APPEAL SUMMARY

Appeal ID: 14749	Project Address: 1332 N Skidmore St
Hearing Date: 3/8/17	Appellant Name: Jeff Shoemaker
Case No.: P-006	Appellant Phone: 971-280-8646
Appeal Type: Plumbing	Plans Examiner/Inspector: preliminary
Project Type: commercial	Stories: 6 Occupancy: A-3, B, M, R-2, S-2, U Construction Type: III-A over I-A
Building/Business Name:	Fire Sprinklers: Yes - Throughout, NFPA 13
Appeal Involves: other: Drywell Location	LUR or Permit Application No.: 16-290087-LU
Plan Submitted Option: pdf [File 1]	Proposed use: Mixed Use

Appeal item 1

To:	Lee Novak	From:	Joe T. Westergreen, P.E. Brett A. Shipton, P.E., G.E.
Company:	Fore Green Development, LLC	Date:	February 23, 2017
Address:	1741 Village Center Circle Las Vegas, NV 89134		
cc:	Jeff Shoemaker, DOWL (via email only) Korey Derrick, DOWL (via email only) Henry Miller, Fore Construction, LLC (via email only)		
GDI Project:	ForeProp-6-01		
RE:	Dry Well Review Overlook & Skidmore N Skidmore Street Portland, Oregon

PROPOSED BASIN AREA
OVERLOOK
FORE GREEN DEVELOPMENT

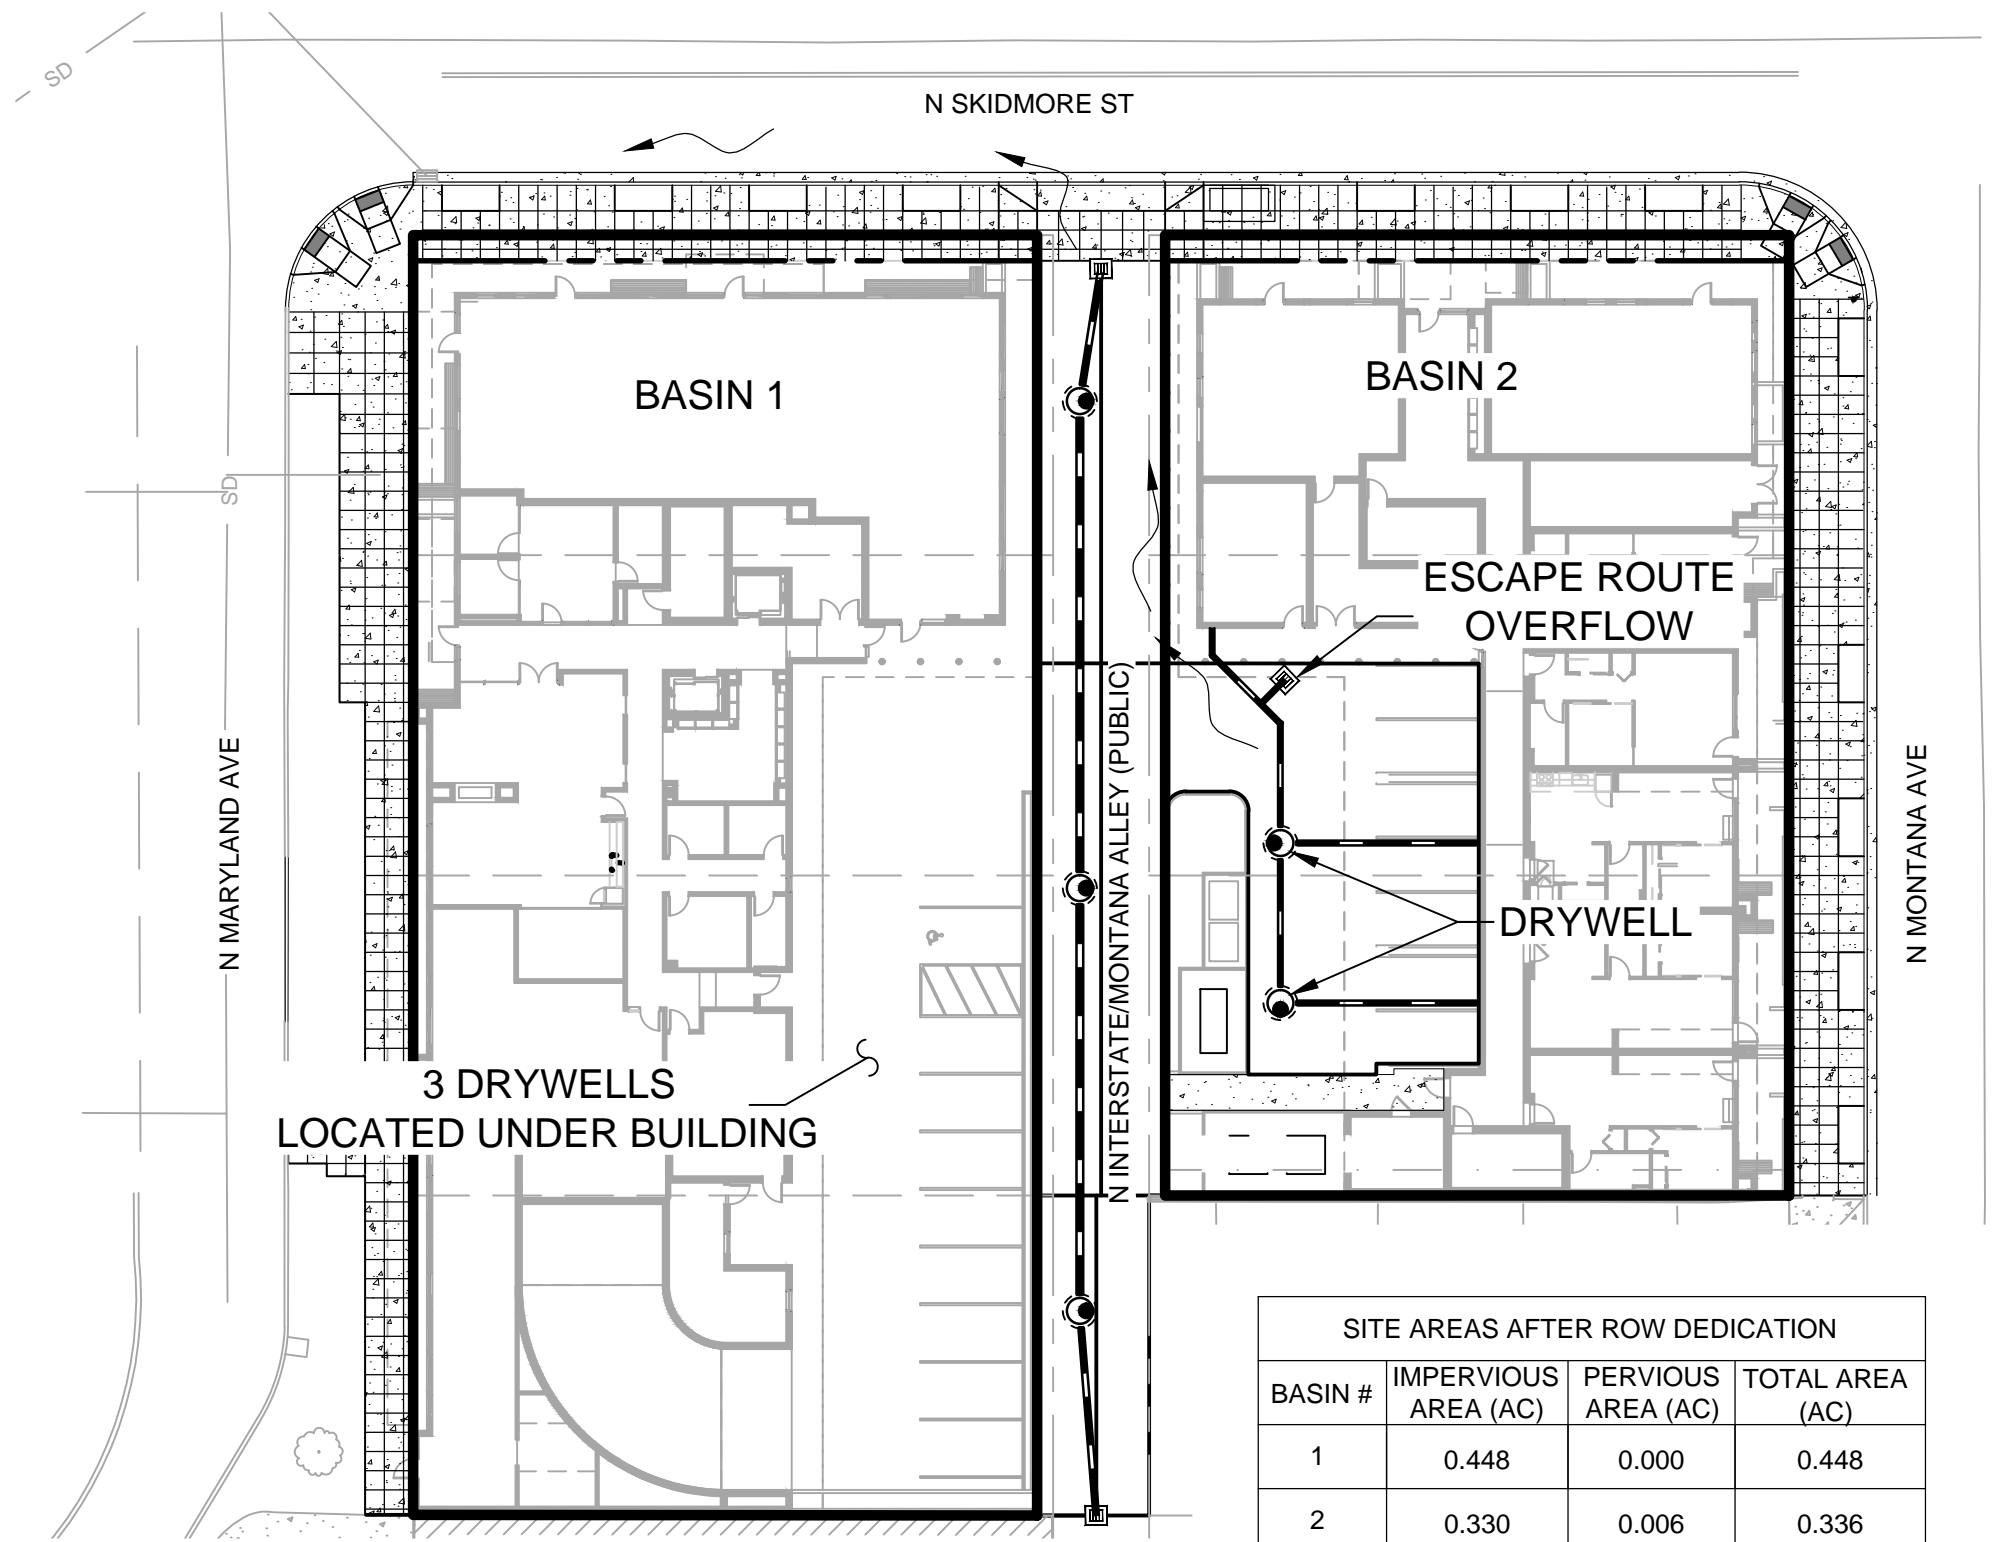
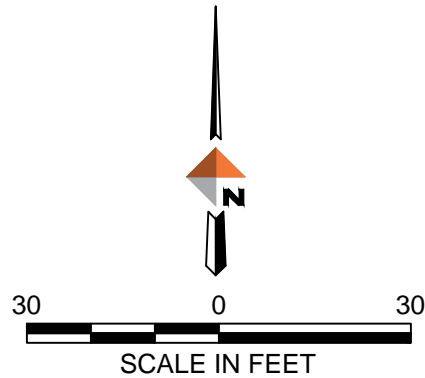
Code Section	OPCS 2014, 1101.5.3.2
Requires	No drywell shall be located closer than 5 feet to a property line nor closer than 10 feet to a building unless approved by the building official.
Proposed Design	<p>The proposal is to manage stormwater by installing 3 drywells on the western lot of the proposed Overlook project, these drywells would be located under the basement with access through a locking manhole lid from the on grade parking area. The drywells will be placed approximately 24' west from the alley right of way line.</p> <p>The appeal request is for the drywells to be located under the basement/parking garage. No request is required from the property line as the drywells are being proposed to meet the minimum setback requirement from the property line. See attached site plan for drywell locations and setbacks from property line.</p>
Reason for alternative	<p>The site is located in a Central Employment zoning area with zero setback requirements. The developer would like to maximize commercial, residential density (per the City's goals to alleviate the housing crises), and underground parking while responsibly managing the stormwater on-site.</p> <p>GeoDesign Incorporated is the geotechnical firm on record for the project and has prepared the accompanying report stating (see attached GeoDesign Memo),</p> <p>"Based on our review of the information provided, the proposed dry wells will not significantly affect bearing capacity of the foots. The dry well structures should have sufficient structural capacity to resist surcharge loads from the adjacent footings."</p>

As shown on Exhibit #2 Proposed Basin Areas are outlined below, an approved escape route is provided for Drywells 4 and 5 within Basin 2. Therefore, these drywells were sized for the 10-year storm. An escape route is not available for Drywells 1, 2, and 3. Therefore, these drywells were sized for the 100-year storm. Table F-1 shows basin size and drywell dimensions. The five drywell depths are approximately 28 feet, with a minimum of 20 feet of perforations.

Drywell System located beneath the building: Granted as proposed

The Administrative Appeal Board finds that the information submitted by the appellant demonstrates that the approved modifications or alternate methods are consistent with the intent of the code; do not lessen health, safety, accessibility, life, fire safety or structural requirements; and that special conditions unique to this project make strict application of those code sections impractical.
